Date	14-Apr-11	Job No.	FL1868.04
Attention	Mr. Thomas Lubozynski, P.E.		
Re:	Response to Request for Add'l Information Class I - Lateral Expansion Construction J.E.D. Solid Waste Mgmt. Facility Permit App No. SC49-0199726-017

**Subject: Response to Request for Additional Information dated 18 March 2011
J.E.D. Solid Waste Management Facility (WACS #89544)
Class I – Lateral Expansion Construction
Osceola County, Florida
(Permit Application No. SC49-0199726-017)**

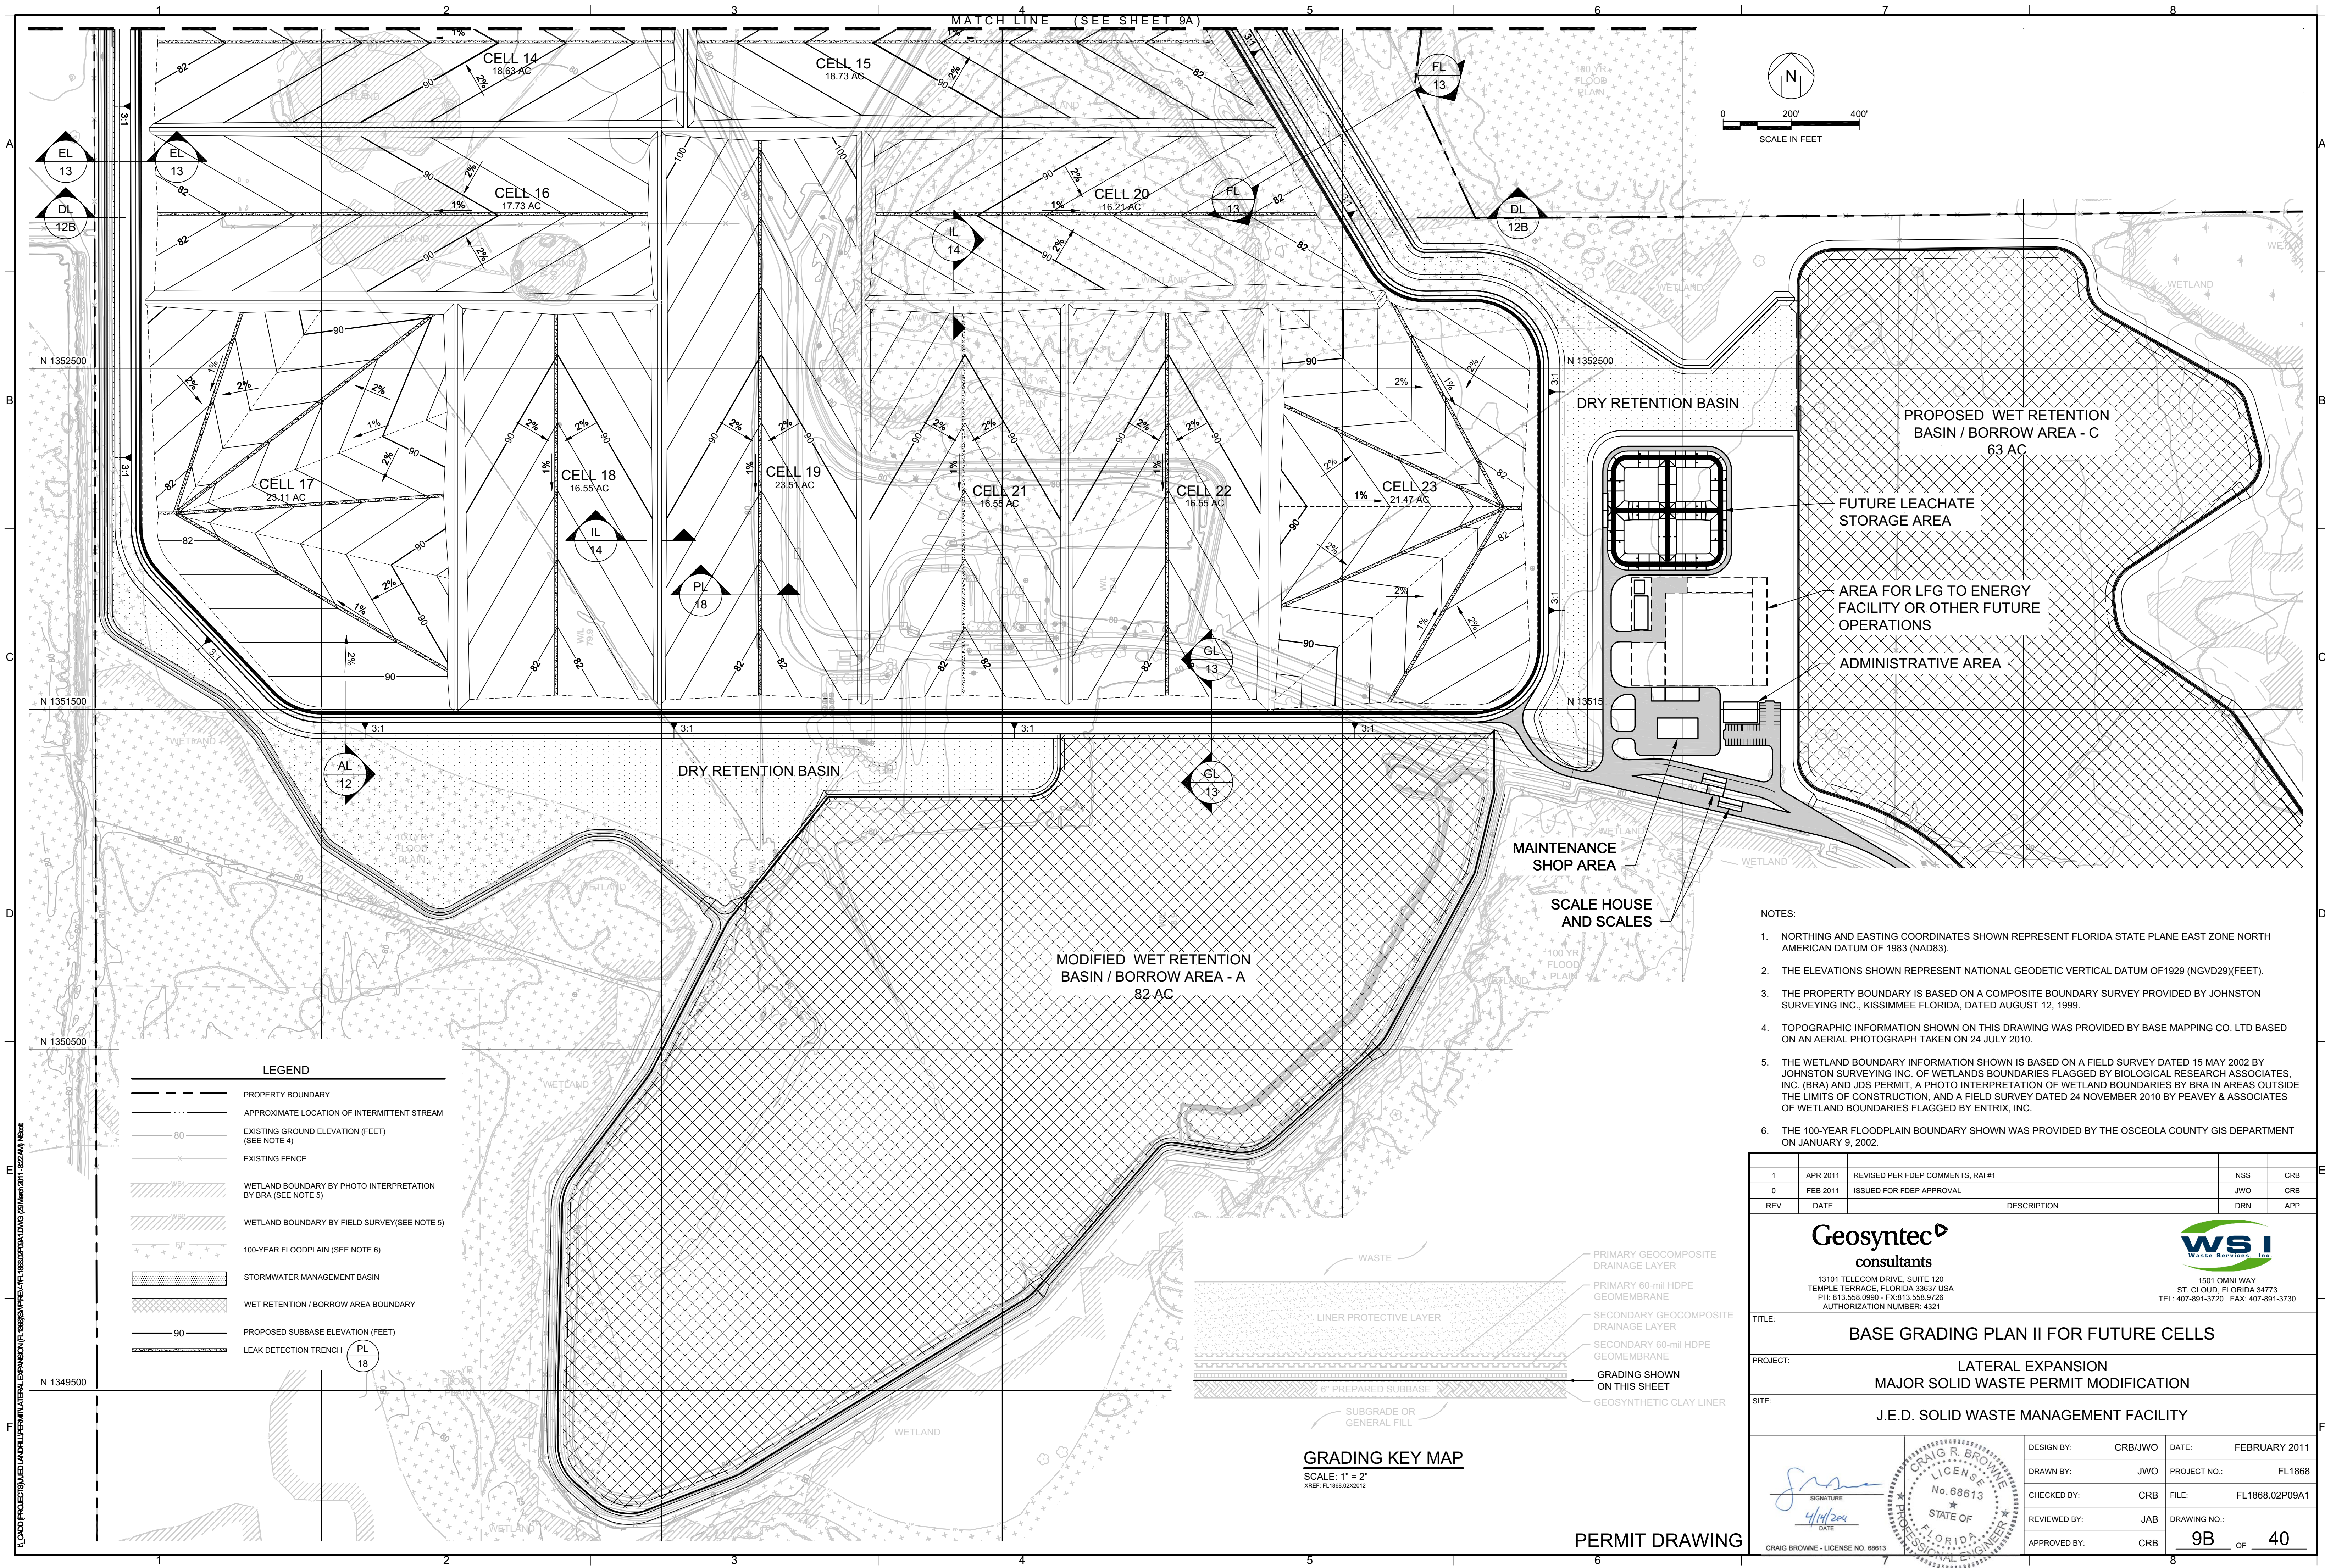
15. Appendix I, Drawings 9A and 9B: These drawings are supposed to depict the prepared subbase. However, they do not show the elevation for the prepared subbase for the leak detection trench. (The leak detection trench is designed to be lower than the leachate collections system as shown in Detail PL on Drawing 18.) Please clarify.

The elevations for the prepared subbase for the leak detection trench are not depicted on Drawings 9A and 9B for clarity. Consistent with the Vertical Expansion Drawings (dated September 2007), these elevations are not depicted because the grading contours would not be legible. In lieu of providing these elevations on the plan view sheet, additional callouts are provided on revised Drawings 9A and 9B that refer the reviewer to Detail PL on Drawing 18. Revised Drawings 9A and 9B are included in **Attachment 1**.

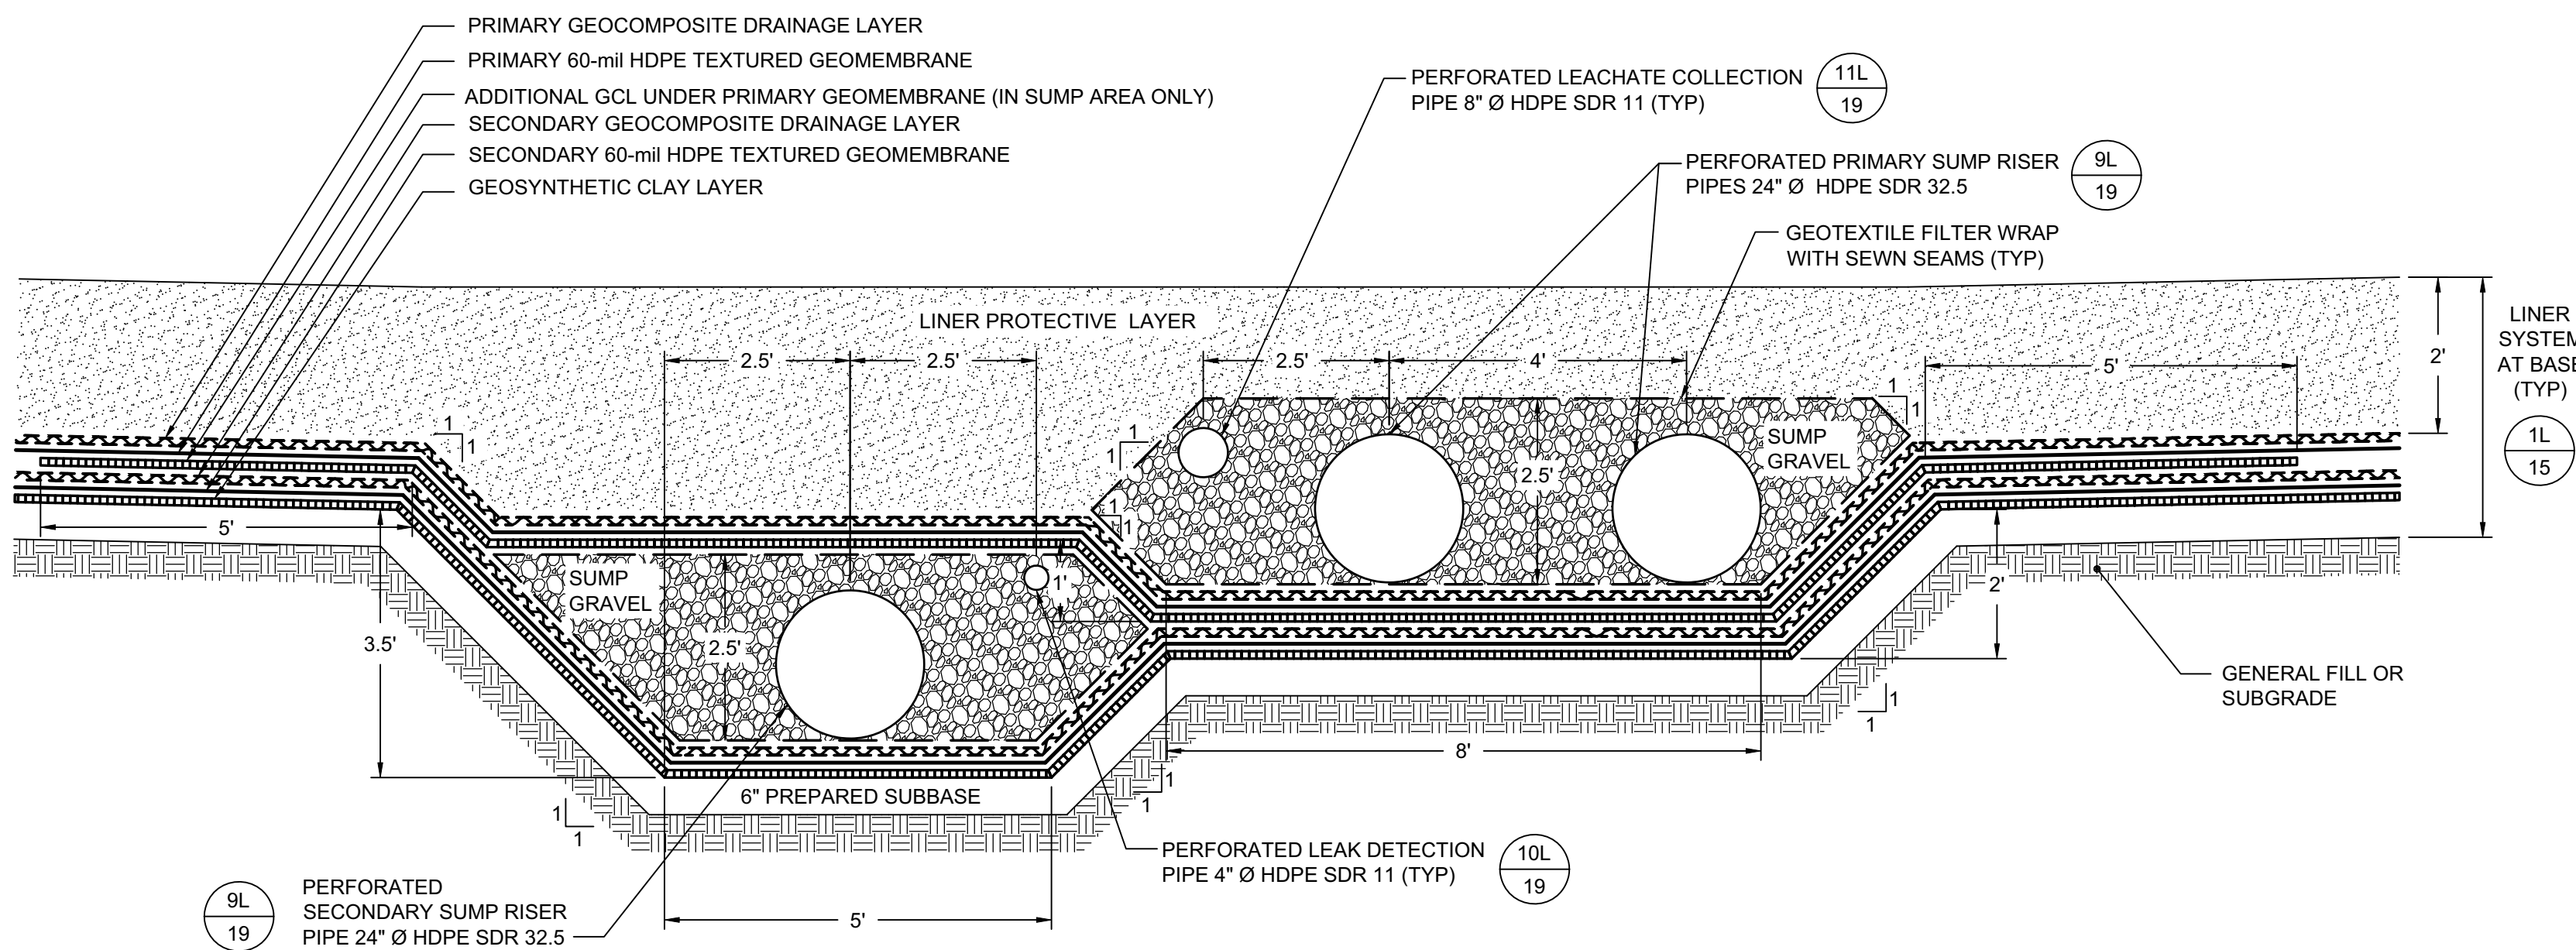
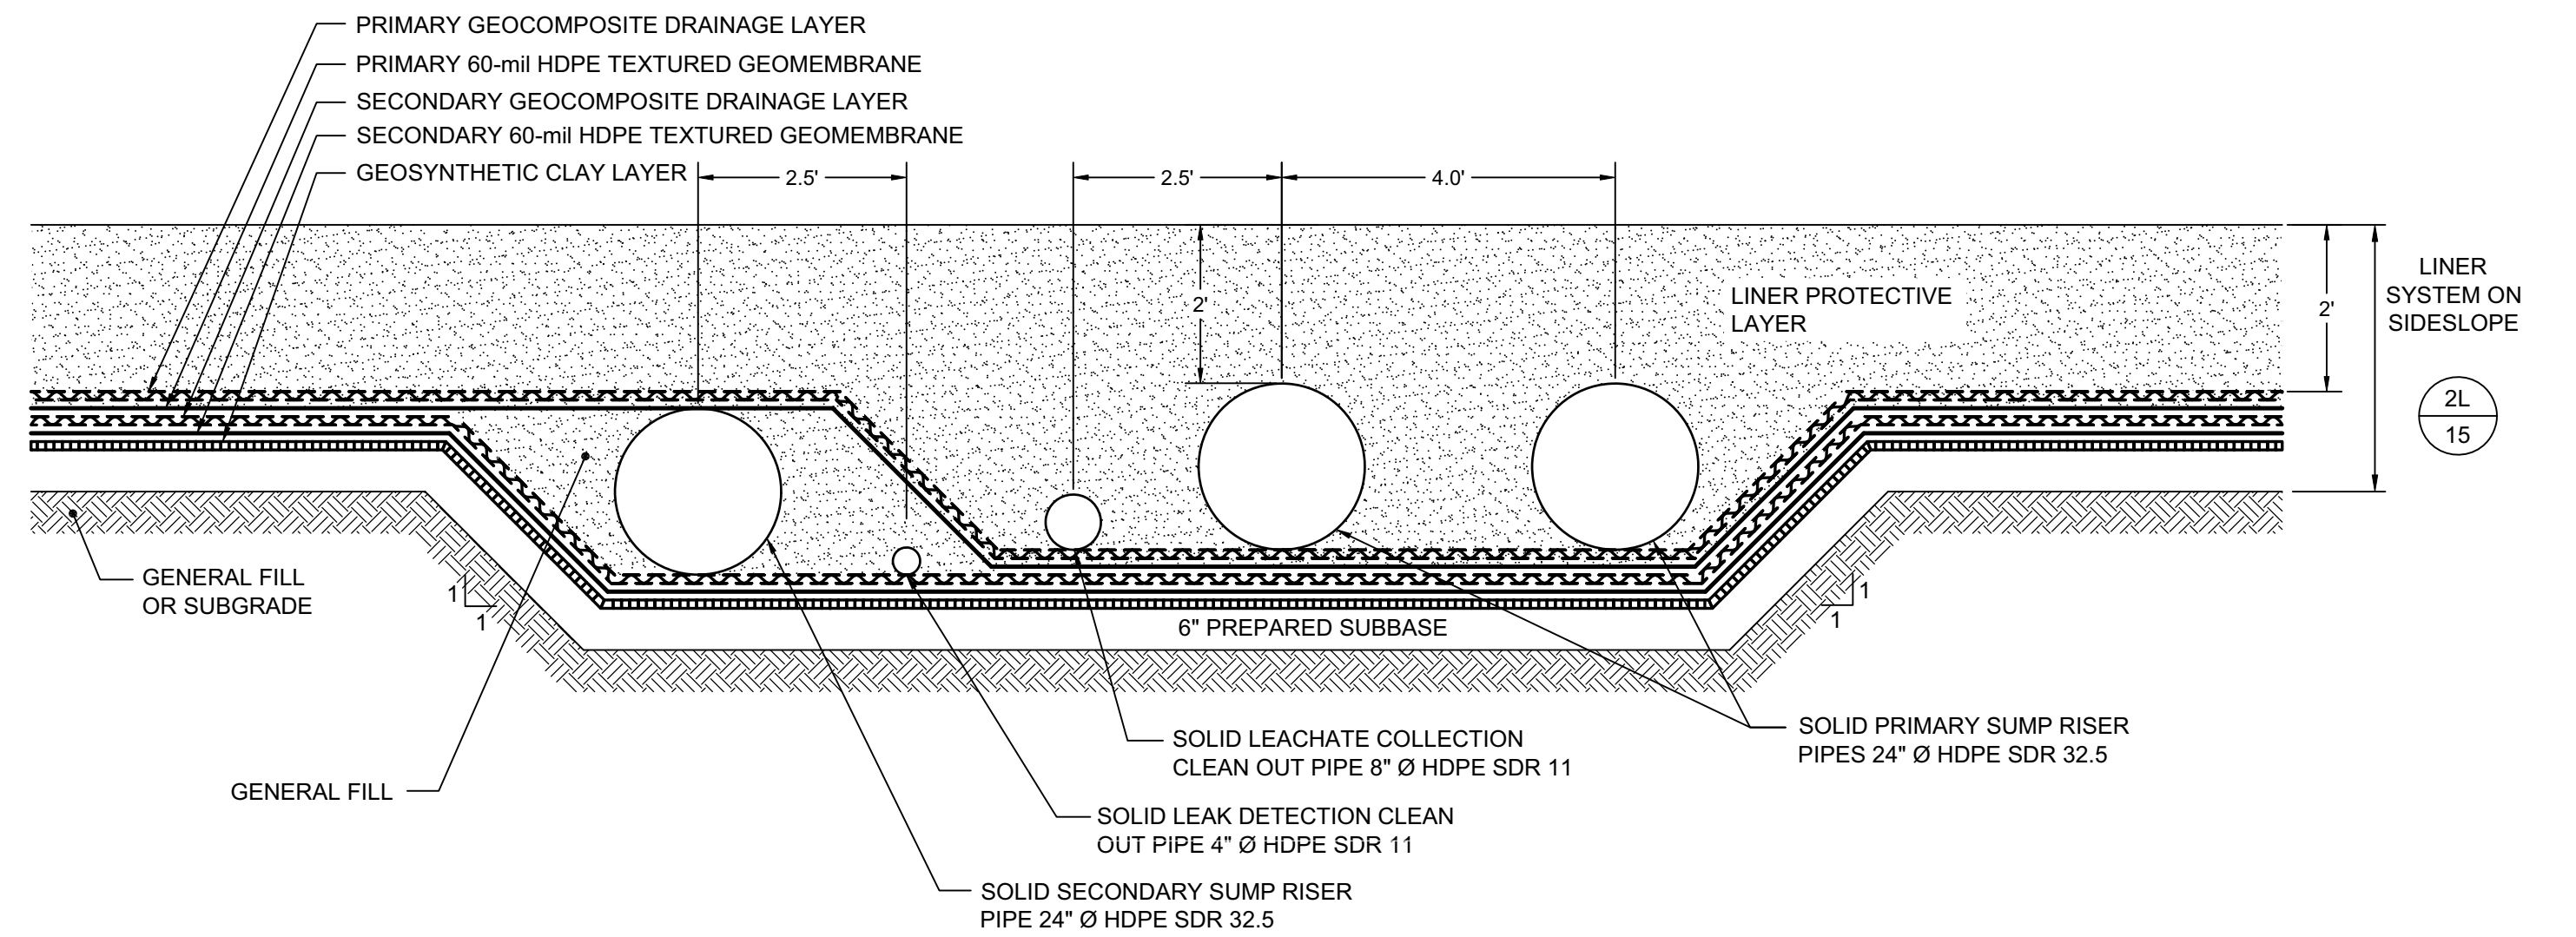
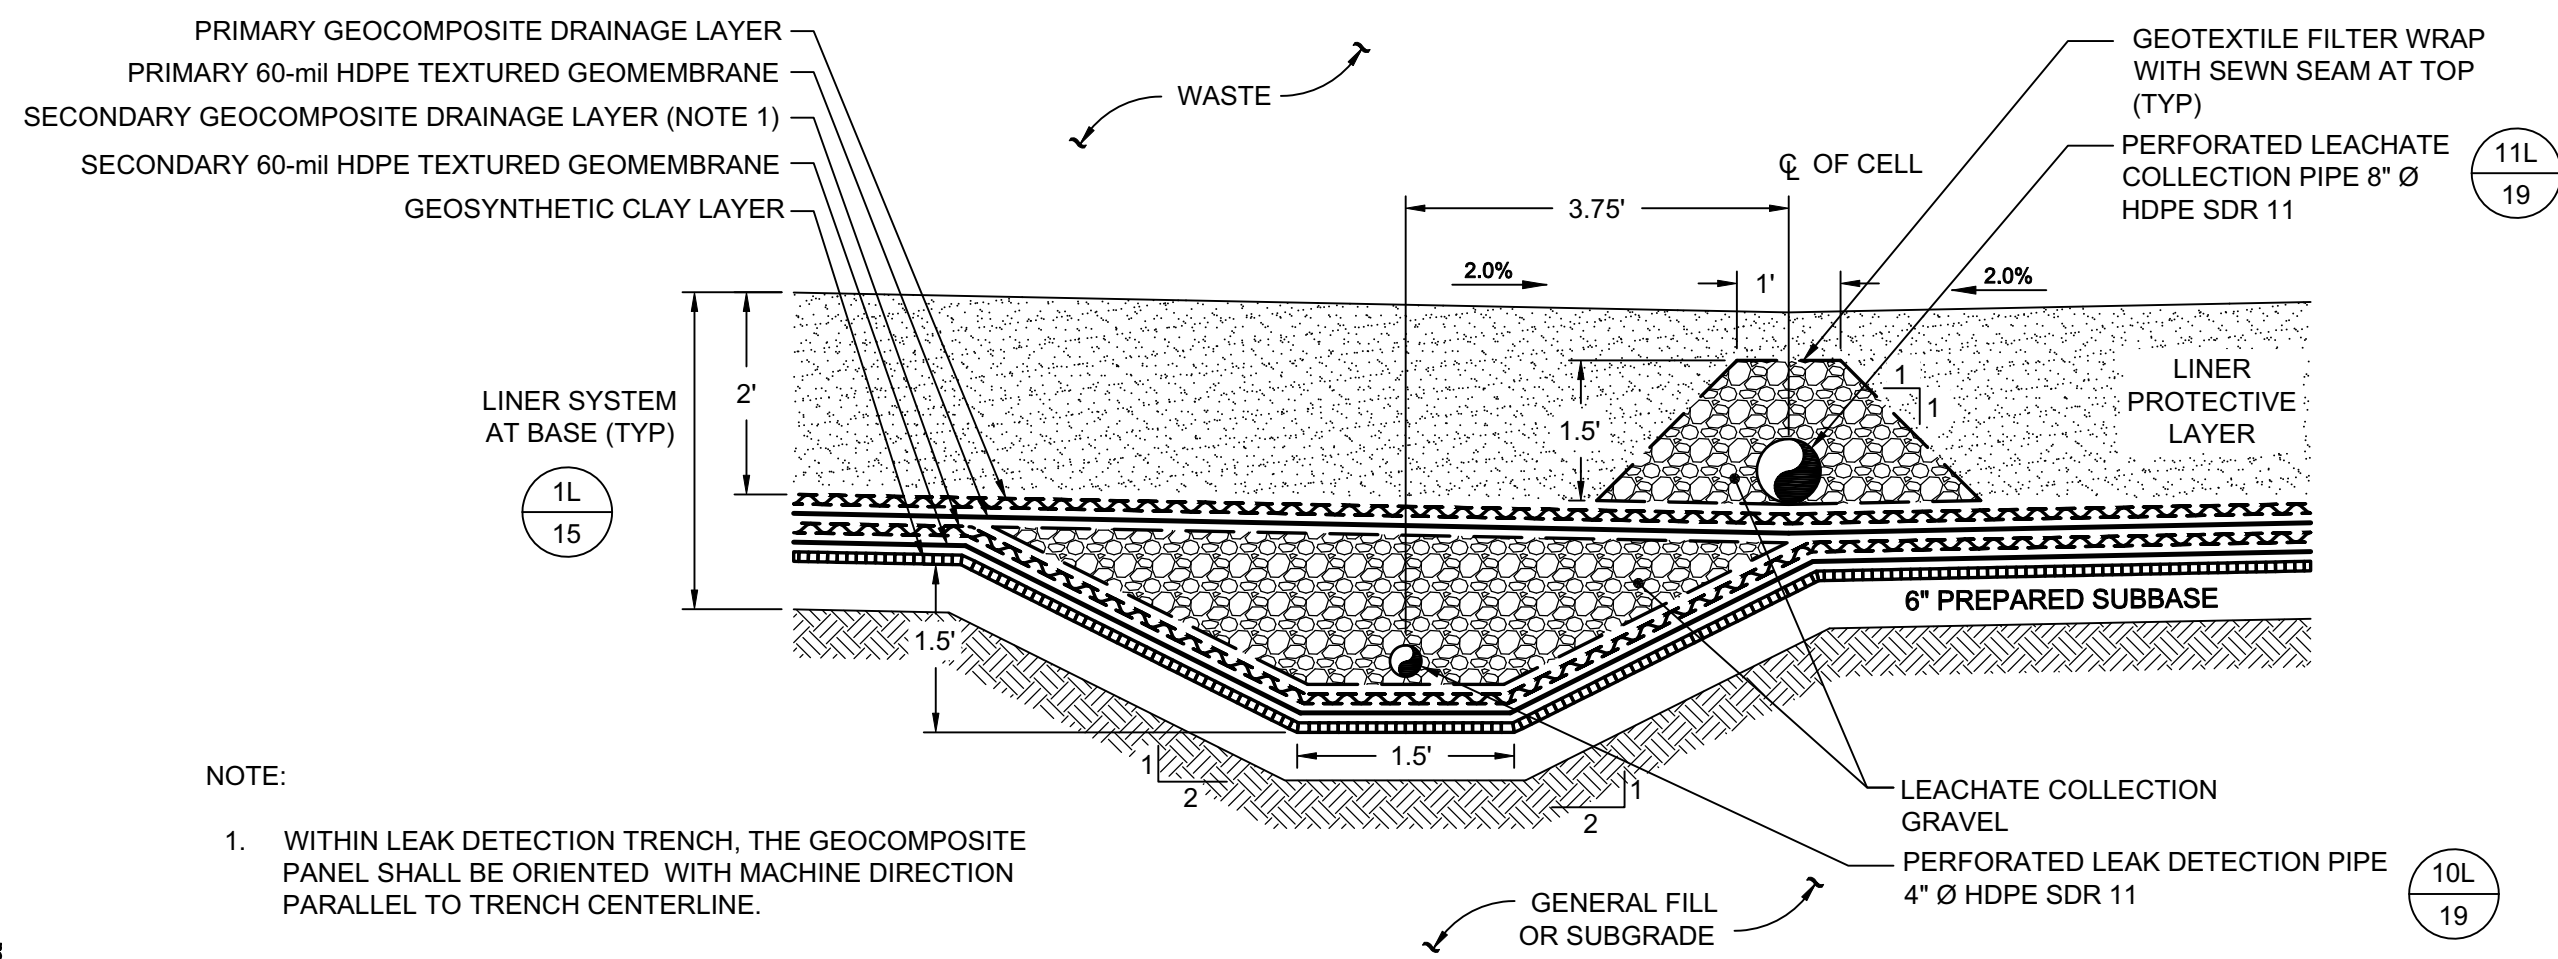
- a. The contours seem to be two feet above the contour elevations in Drawings 9A and 9B. However, according to the legend these are the subbase elevations, just like those depicted on Drawings 9A and 9B.*
- b. The cross section drawing of the liner and leachate collection system (Detail PL on Drawing 18) does not indicate that the leachate collection system will be two feet above the subbase elevation.*
- c. Please clarify.*

Drawings 10 and 11 have been revised to indicate the correct legend text for top of liner protective layer grades. In addition, the details on Drawing 18 have been revised to indicate that the liner protective layer of the leachate collection system will be two feet above the subbase elevation. Revised Drawings 10, 11, and 18 are included in **Attachment 1**.
